PLACER COUNTY WATER AGENCY
SINCE 1957

SUBJECT: Comments on BDCP/CalWaterFix RDEIR/SDEIS

SUBJECT: Technical Comments on Bay-Delta Conservation Plan Modeling

Effects of Implementation of the Bay Delta Conservation Plan

Figure 1. Inflow to Trinity, Shasta, Oroville, and Folsom Reservoirs – NAA, NAA-ELT and NAA-LLT

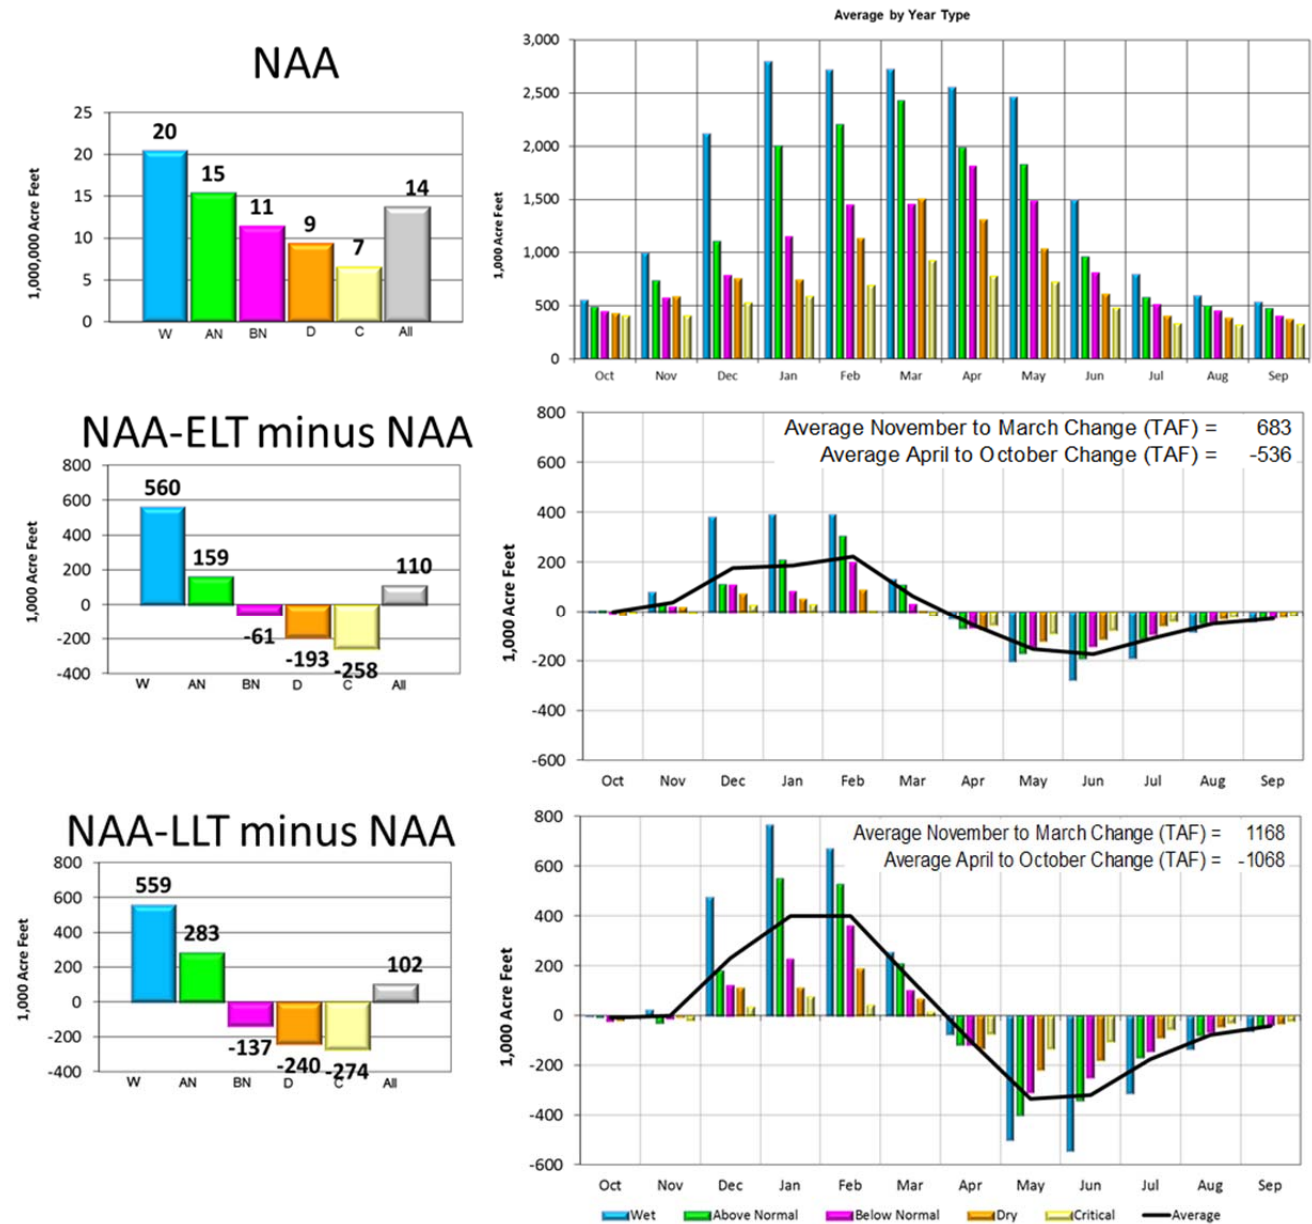
The significance of changed hydrology between the three without project baselines (NAA, NAA-ELT, and NAA-LLT) is illustrated below in Figure 1. The figure illustrates the projected combined inflow of Trinity, Shasta, Oroville, and Folsom Reservoirs under the NAA and the change relative to the NAA for the NAA-ELT and NAA-LLT baselines. BDCP baselines show Trinity, Shasta, and Oroville inflow are projected to increase overall, but with a significant shift from spring runoff to winter runoff and increases in wetter years with decreases in drier years.

Comparison of inflow changes illustrated in Figure 1 and Figure 2 show the effects of climate change are large in the American River Basin relative to changes in other river basins. Total changes illustrated in

Figure 1 show wetter conditions in wet years and drier conditions in dry years when considering the four basins together. However, climate change in the American River Basin for the LLT shows drier conditions in all year-types. Additionally, a large percentage of the dry and critical year inflow reduction, 57 and 37 percent respectively, for the combined four basins occur in the American River Basin. By comparison, runoff from the American River at Folsom is approximately 20 percent of the sum of runoff of the Trinity, Sacramento, Feather, and American rivers.

Figure 2. Projected Inflow to Folsom Reservoir – NAA, NAA-ELT and NAA-LLT

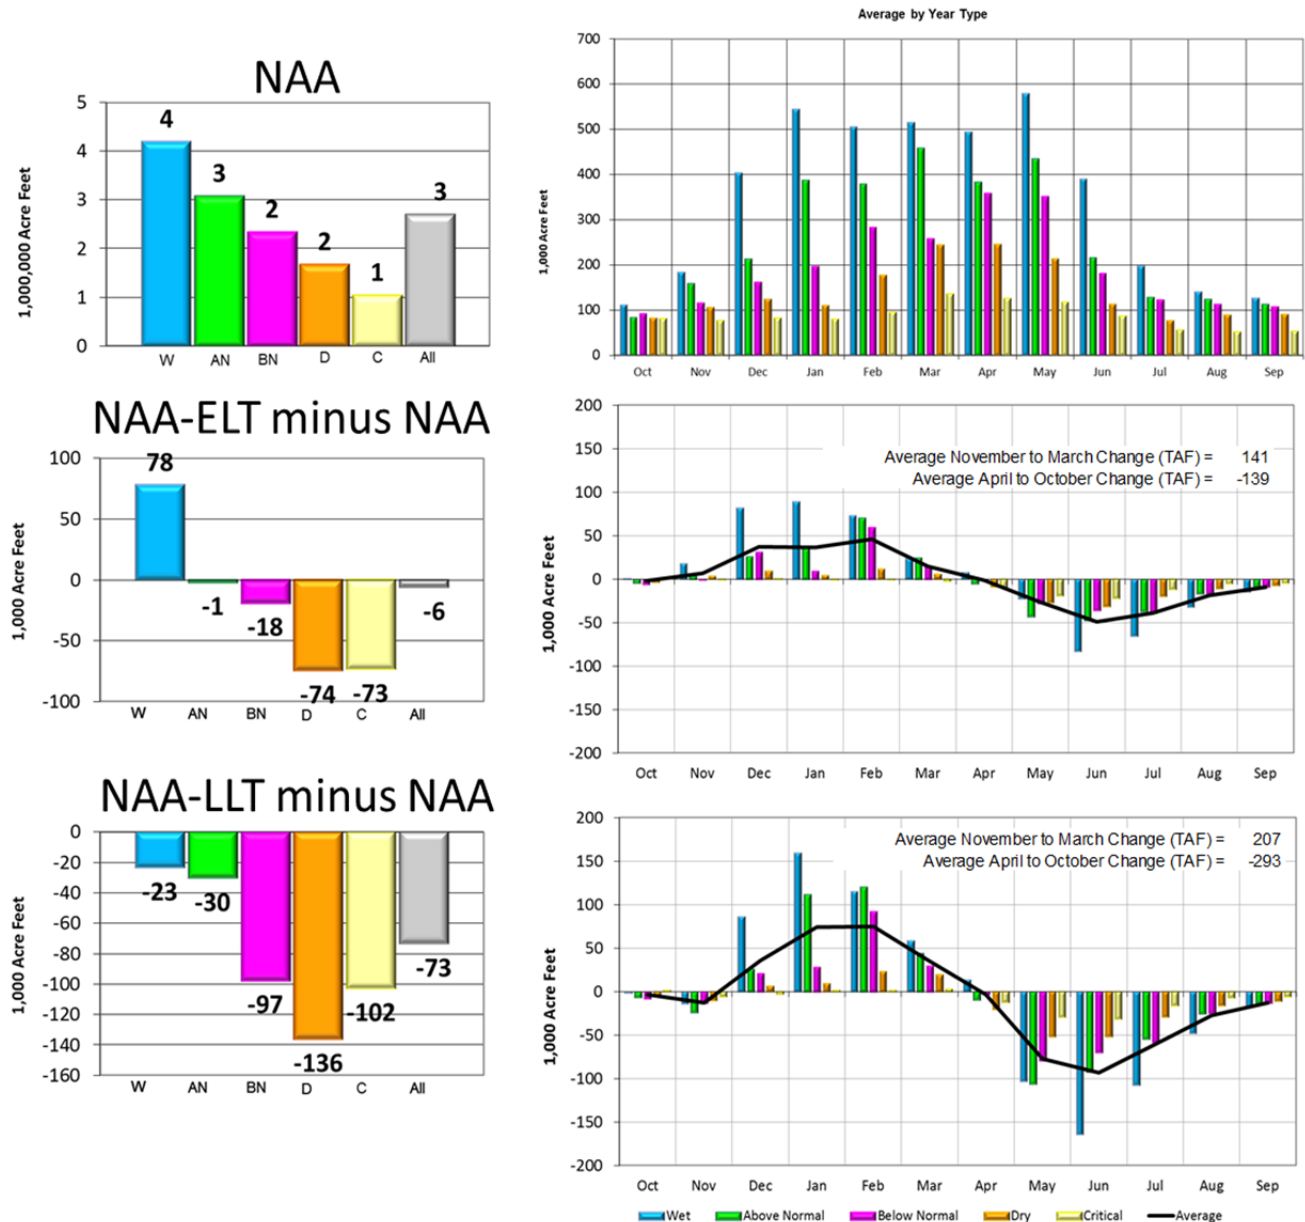
The effect of assumed climate change on average annual Folsom Reservoir inflow in the NAA-ELT scenario is minor, but causes decreases in inflow of about 70 TAF in the NAA-LLT scenario. The spring to winter shift in runoff is also projected for Folsom Reservoir inflow. Figure 2 is an illustration of Folsom inflow under the NAA and the change relative to NAA for the NAA-ELT and NAA-LLT baselines. To properly incorporate climate change into modeling of Folsom Reservoir and the American River, climate change effects must be applied to flows and reservoirs upstream from Folsom, which was not done. There is significant storage capacity in the upper American River watershed in PCWA’s Middle Fork Project and the Sacramento Municipal Utility District’s (SMUD) Upper American River Project. The

operation of Folsom is significantly affected by changes in upstream conditions and operations.⁹ Because climate change in BDCP modeling is imposed on the American River by adjusting only the inflow to Folsom only, however, the effect on the American River is likely misrepresented in the BDCP NAA-ELT and NAA-LLT scenarios.

Figure 3. Folsom Reservoir Carryover Storage

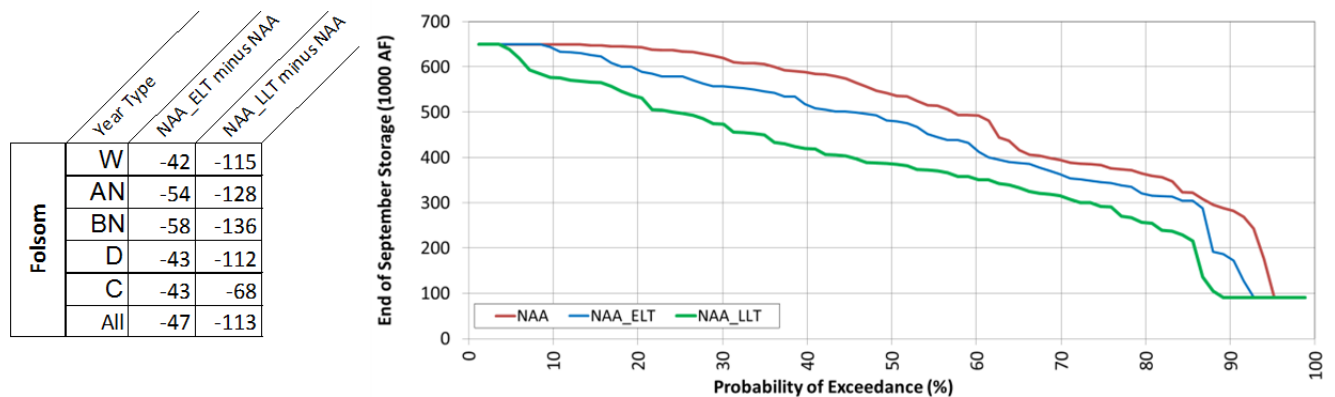
For Folsom and other upstream CVP and SWP reservoirs, the shift of in timing of inflows along with a continuing need to satisfy downstream environmental requirements and demands significantly affects carryover storage. Because of climate change’s assumed effect on hydrology and the lack of CVP/SWP operational adaptations in the BDCP modeling, the CVP and SWP simply cannot satisfy water demands and regulatory criteria imposed on them in the NAA-ELT and NAA-LLT modeling scenarios. Figure 3 illustrates change in carryover storage in Folsom Reservoir. The relatively high frequency (approximately 10% of time) of minimum storage occurring at Folsom Reservoir leads us to question whether the NAAs reflect credible or defensible operations. The projected occurrences of low and dead storage conditions projected by the BDCP modeling result in severe reduction of flow available to sustain habitat in the Lower American River and severe reductions in water supply reliability.

Figure 4. CVP North of Delta M&I Water Service Contract Allocation

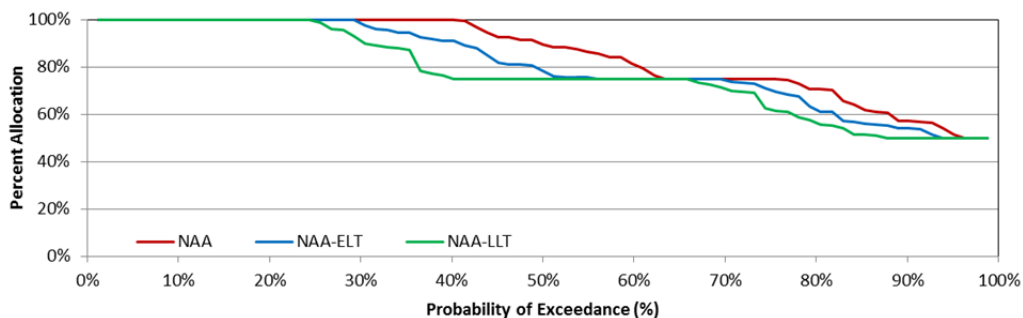
Assumed effects of climate change and lack of adaptation reduces CVP water supply allocations to American River CVP Water Service Contractors. Figure 4 contains exceedance probability plots of CVP M&I allocations for the NAA, NAA-ELT, and NAA-LLT scenarios. Full allocations are made 40% of the time under the NAA, this is reduced to about 30% in the NAA-ELT, and full allocations are made about 25% of the time in the NAA-LLT. The occurrence of 50% allocation increases from about 4% in the NAA to about 7% in the NAA-ELT and to about 12% in the NAA-LLT. In addition to reduced water service contract allocations, water supply allocations under any right cannot be satisfied due to low storage levels in Folsom Reservoir and low flow in the Lower American River. It is not physically possible to divert water for M&I use from Folsom Reservoir when reservoir storage drops below about 100,000 acre-feet because, at that level, the M&I intake in the reservoir would be dry. In addition, flows in the lower American River below about 500 cfs make it impossible for the City of Sacramento to divert water at its Fairbairn diversion. The water-supply and other effects of these physical conditions occurring in the NAA scenarios are not identified or evaluated in the draft BDCP EIR/EIS.

Figure 5. NAA-LLT and Alt 4-LLT Simulated Folsom Reservoir Elevation

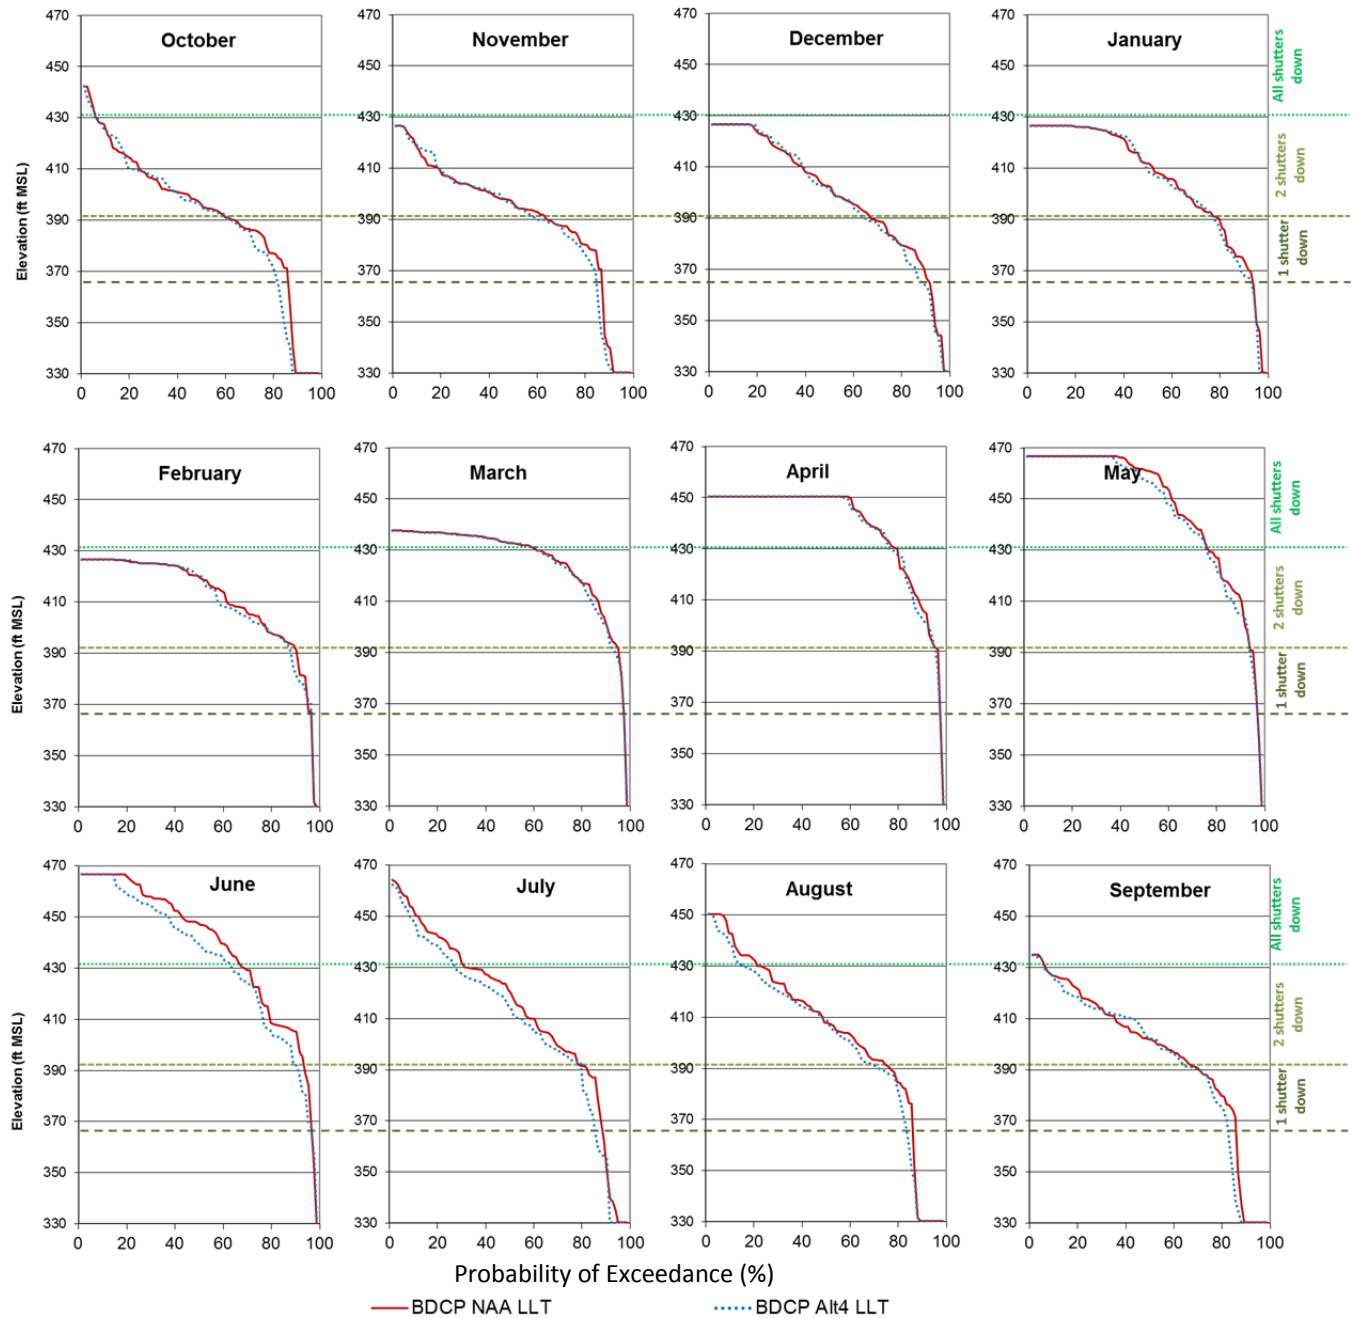
Figure 5 is a comparison of simulated monthly Folsom Reservoir water surface elevations for the baseline and with-Project scenarios. A probability of exceedance chart for each month illustrates differences between the two model simulations and potential Project effects. Dashed horizontal lines indicate water surface elevations when groups of shutters on the intake device must be removed. For example, when the water surface elevation goes below approximately 430 feet, the first group of shutters must be removed. These lines are 30 feet above the top of shutter elevations for the three groups of shutters to account for water depth to prevent the formation of a vortex and cavitation at the intake which would prevent diversion.

Results presented in Figure 5 illustrate that Folsom Reservoir water surface elevation is lower under the with-Project scenario. The largest difference in Folsom elevation occurs from June through August and can affect temperature management by changing when shutters are removed. Shutters are removed from Folsom Dam's intakes in order to access colder water located lower in the reservoir. While removing shutters causes the temperature of water diverted and released from the reservoir to drop almost immediately, that effect does not cause release temperatures to remain cooler indefinitely. Accordingly shutters must be removed strategically.

The timing of shutter removal at Folsom Reservoir would change in the with-project condition. For example, in August the probability of all three shutters being in use is reduced from approximately 25 percent to 15 percent, and the probability of at least one shutter still in used is reduced from approximately 90 percent to 85 percent. Figure 6 is a comparison of simulated monthly Folsom

Figure 6. NAA-LLT and Alt 4-LLT Simulated Folsom Reservoir Storage

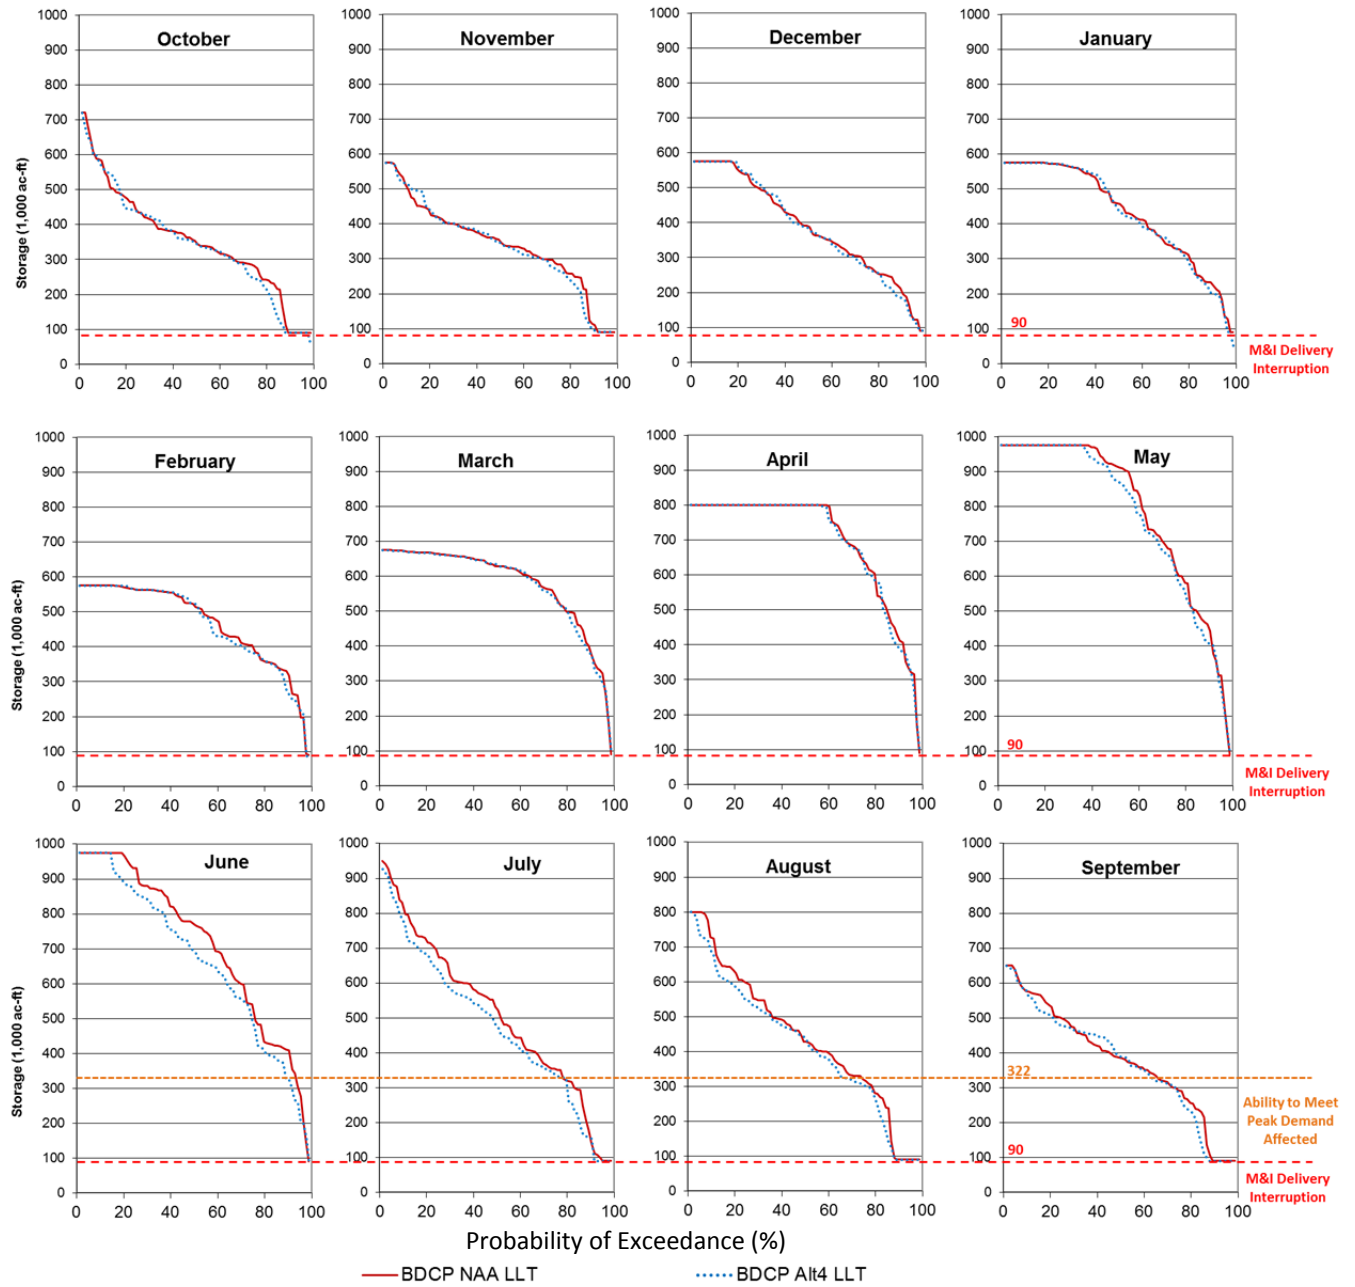
Reservoir storage for the baseline and with-Project scenarios. A probability of exceedance chart for each month illustrates differences between the two model simulations and potential Project effects. Dashed horizontal lines in Figure 6 represent storage levels below which M&I water purveyors cannot meet peak demands (322 TAF) with diversions from Folsom (illustrated for peak demand months only) or when M&I diversions are interrupted because water levels in Folsom are below the M&I intake (90 TAF). Results summarized in Figure 6 show that Folsom Reservoir storage is more likely to be lower under the BDCP Alt4-LLT than the NAA-LLT particularly in peak summer months. Lower storage impacts the ability of the water purveyors that divert directly from Folsom Reservoir, as well as downstream purveyors on the American River, to meet peak demands in the summer and increases the probability of M&I delivery interruptions.
